Metropolitan Development Commission Regional Center Hearing Examiner (December 1, 2022) Meeting Agenda

STAFF REPORT

Case Number	2022-REG-071
Address (approx.)	227 West 14 th Street, 1355 North Senate Avenue, 1302, 1310 and 1318 North Capitol Avenue
Location	Center Township, Council District # 11
Petitioner	Indiana University Health, Inc., by J. Murray Clark
Zoning	CBD-S (RC)
Request	Regional Center Approval for provide for the construction of a mixed-use support building to be used as a parking garage, loading dock and logistics space, commercial office and retail uses, and bulk medical gas storage in an exterior yard along 13 th Street. The building would be five stories in height, with alternate building heights up to eight stories.

Site Plan (top); Landscape plan

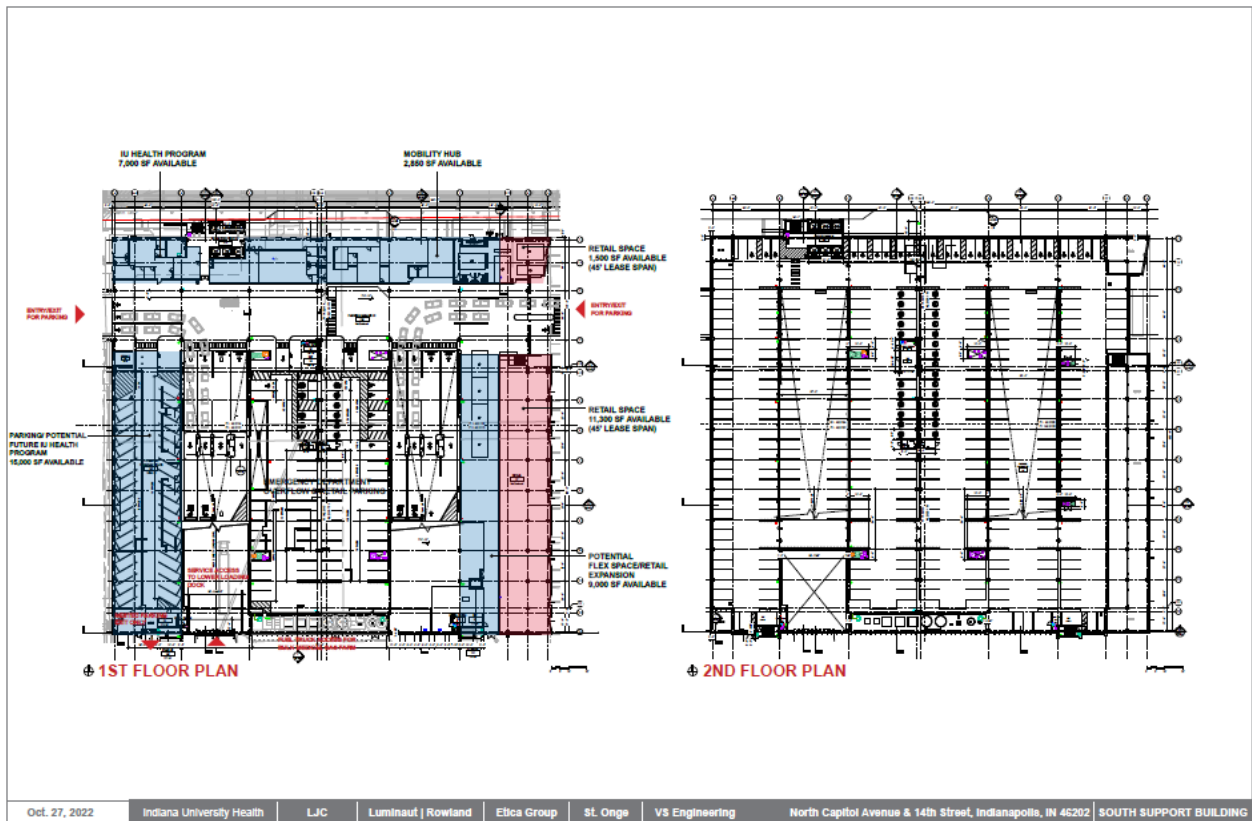
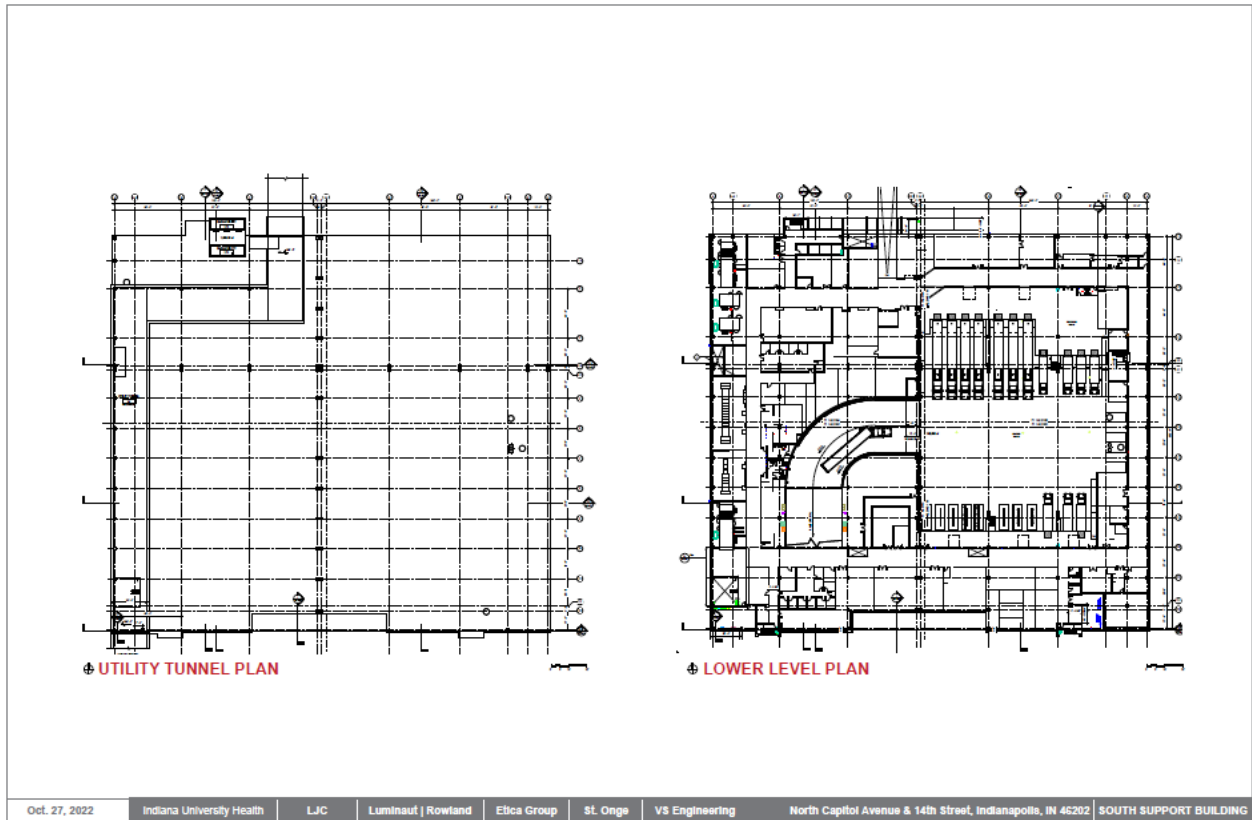
1. While a landscape plan has been submitted, it does not detail plant species. Staff requests that detailed landscaping plan be submitted and subject to planning staff review and approval, prior to installation. (Guidelines US 1.3.2, CA 4.6.1, CA 4.6.4, CA 4.6.5, and CA 4.6.7 apply).

Staff **recommends approval** of the Regional Center Approval petition subject to the following conditions:

1. Summary items 1 and 2 must be met.
2. Address numerals shall be installed on the building façade prior to occupancy of the building, per CA 2.5.8.
